## GTR9-8-06

Informal document GRSP-53-29  
(53rd GRSP, 13 – 17 May 2013,  
agenda item 3 (a))

### **GTR No. 9 – Draft proposal for Amendment 2**

Note: The text reproduced below was prepared by the chairman of the informal working group on the global technical regulation No. 9 (Pedestrian safety)-Phase 2 proposing the use of a flexible pedestrian lower legform impactor in the global technical regulation No. 9 (pedestrian safety) - Phase 2. The modifications to the current text of gtr No. 9 on pedestrian safety are marked in bold for new or strikethrough for deleted characters. Text in square brackets is still under discussion and consideration of the informal group.

Figure 12: Flexible lower legform impactor; nominal dimensions and C.G. centre of gravity locations of femur, knee joint and tibia (Side view)

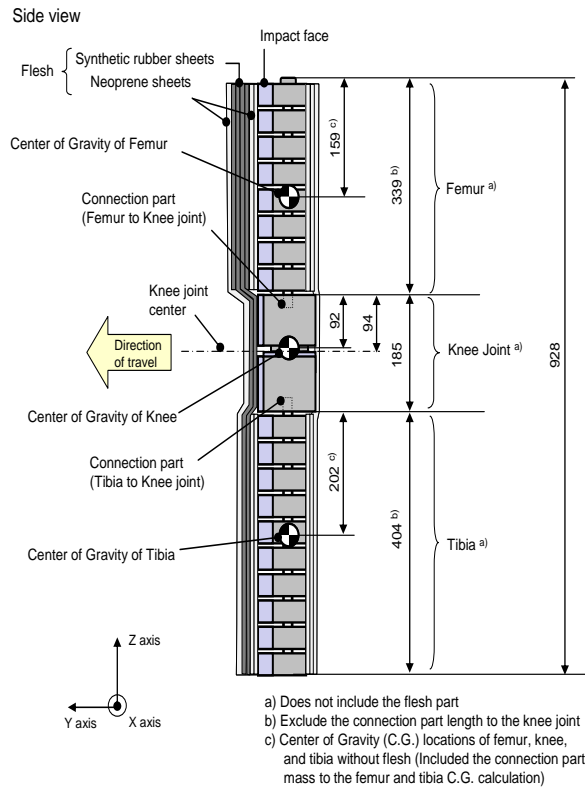
Kommentiert [TK3]: In fact, adding the tolerances to the figure 12 would make it possible to delete this sentence.

Kommentiert [TK6]: Again, it is felt that tolerances are much too big and should be reduced to 10 % of these values. In addition, the whole section is sufficiently described in figures 12 and 13 if the tolerances were added there.

Kommentiert [TK8]: The description here seems to be imperfect to describe a point in space. The tolerance needs to refer to a point that can be measured directly, e.g. 202 mm from the bottom of the tibia.

Figure 13:- Flexible lower legform impactor; schematic plan views of femur, tibia, and knee dimensions (Top view)

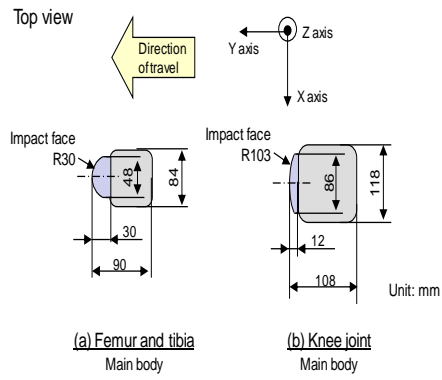
Kommentiert [TK4]: Better: Add tolerances in figure 13 (a) and say "The cross sectional shape of the femur and the tibia main body segments shall be as defined in figure 13 (a)."

Kommentiert [TK5]: Better: Add tolerances in figure 13 (b) and say "The cross sectional shape of the knee joint shall be as defined in figure 13 (b)."

Figure 47 21: Flexible lower legform impactor Lower legform-to bumper tests for complete vehicle in | normal ride attitude (left) and for cut-body mounted on supports (right) (see paragraph 7.1.1.3.) "

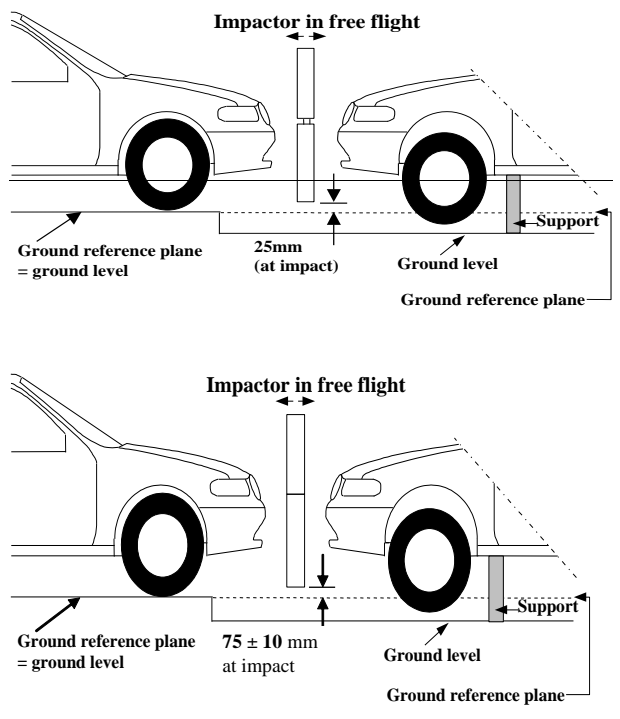
**Kommentiert [TK17]:** It needs to be clarified that the bottom of the impactor does NOT consider the protective cap!

**Figure 27: Flexible lower legform impactor test set-up for dynamic lower legform impactor certification test, (pendulum test type (see paragraph 8.1.2.4.))**

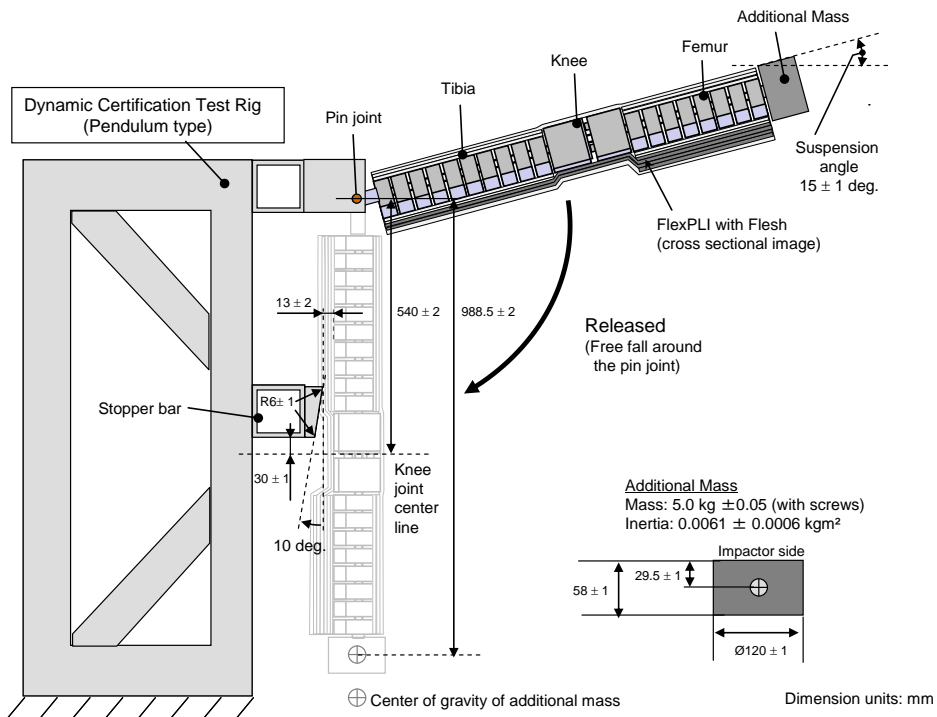
**Kommentiert [TK30]:** The drawing should say test rig for pendulum test.

**Kommentiert [TK31R30]:** Also, the impactor should be named "FlexPLI with flesh and skin".

**Figure 28:** Flexible lower legform impactor - Test set-up for dynamic lower legform impactor certification-verification test, (inverse type-test; (see paragraph 8.1.3.4.)

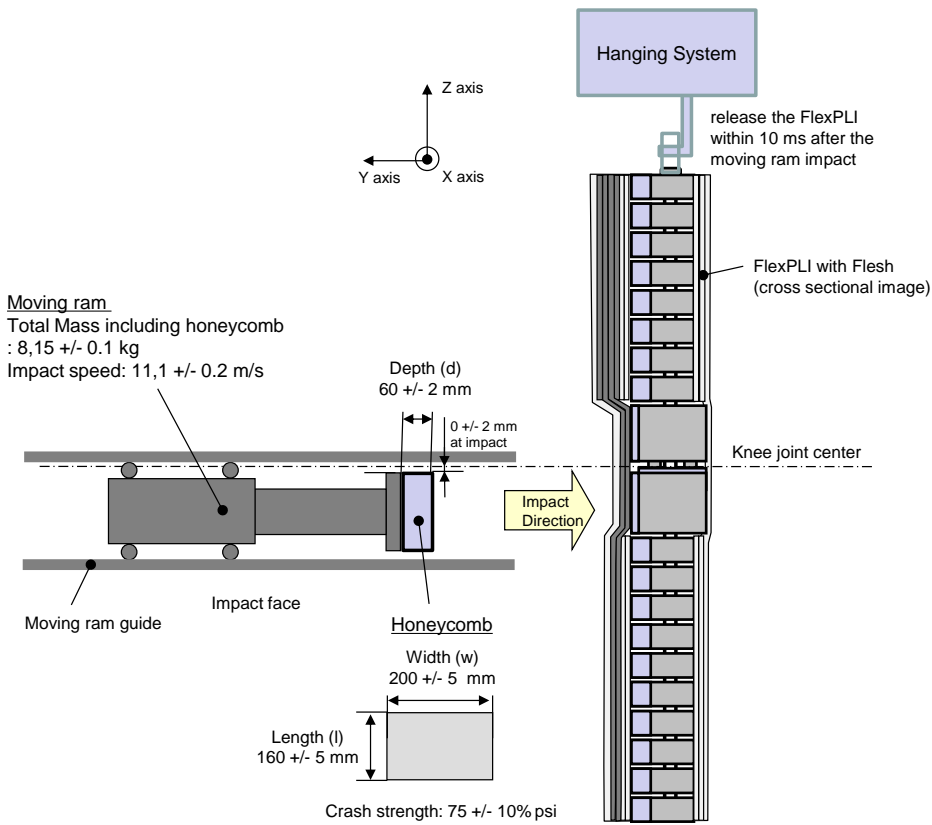
**Kommentiert [TK27]:** Should be moved to the respective figure (figure 28).

**Kommentiert [TK32]:** The honeycomb cell should say wide and high and should mention the paper cover (max. 1 mm thick).
